BGA TECHNICAL COMMITTEE

TNS 1/79

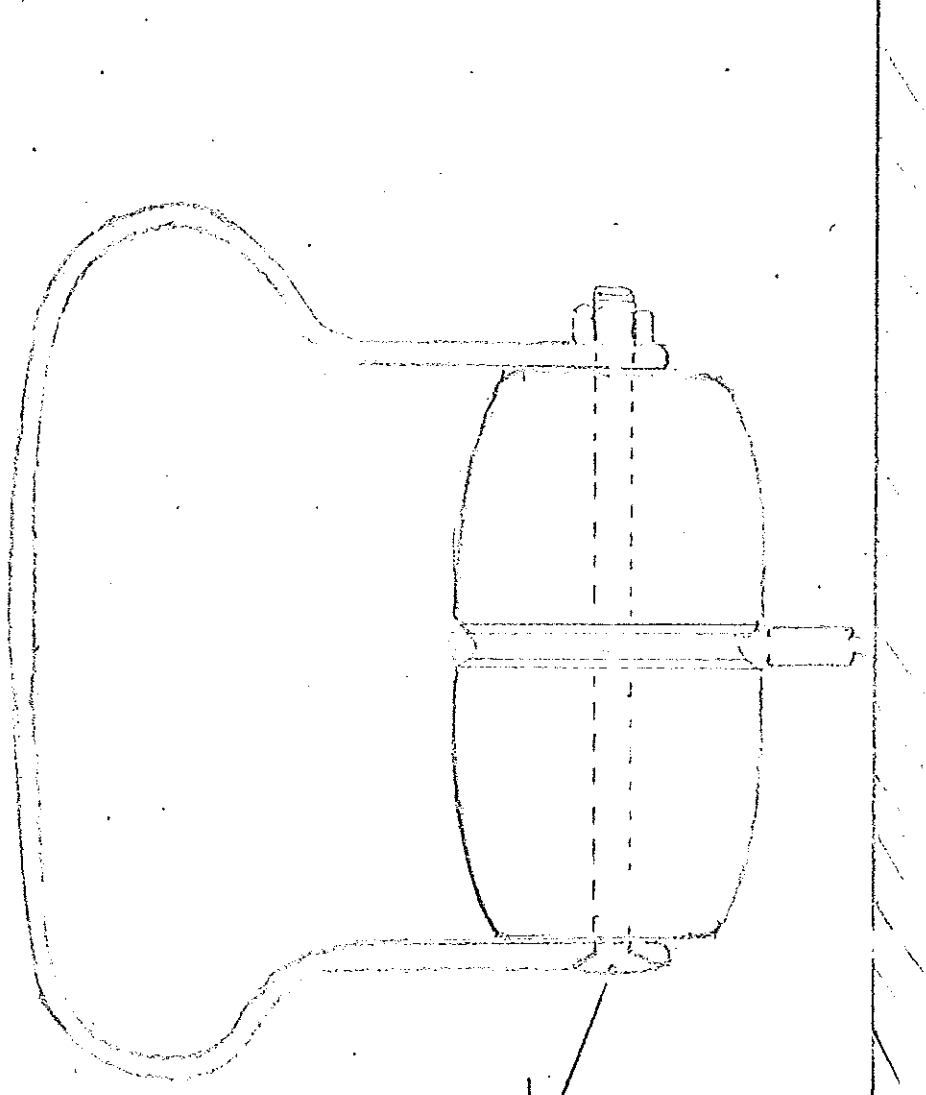
REASON Main wheel rubbing against the landing gear main fork.

DESCRIPTION The change of the main wheel tire type has decreased the gap between the main fork and the tire to 2-3 mm (3/32 - 1/8 in), which is not enough because of the dynamic behaviour of the tire in landing impact.

- 1 Check if the main tire is Goodyear 5.00 - 5 6 ply TSO C62b part no. 505C61G1. (The type of the tire in question can be used in PIK-20 D models after s/n 20610 having modified main fork.)

- 2 If it is, measure the gap between the tire and the main fork diagonal brace ( $\varnothing$  12 x 1 mm). The tire pressure should be 2.5 Bar (35 psi). If the gap is less than minimum allowed 5.0 mm (3/16 in), remove the wheel and inspect the <sup>wheel fork</sup> tube wear.

- 3 If the tube is worn less than 0.3 mm (0.012 in), repair according to the PIK-20 D Repair Manual page III-11.
- 4 If the tube is worn more than 0.3 mm, the fork must be repaired. Before repairing contact the nearest PIK-20 agent or repair station.

- 5 The tire must be changed to one of the following 5.00 -5 6 ply aircraft tires if the gap is less than 5.0 mm (3/16 in):
  1. Goodyear TSOC626 part no 505C61-4

2. Continental Type III
  3. McCready TSOC62b Type IIIThe gap must be minimum 5.0 mm (3/16 in).  
Contact the nearest PIK-20 agent or repair station.
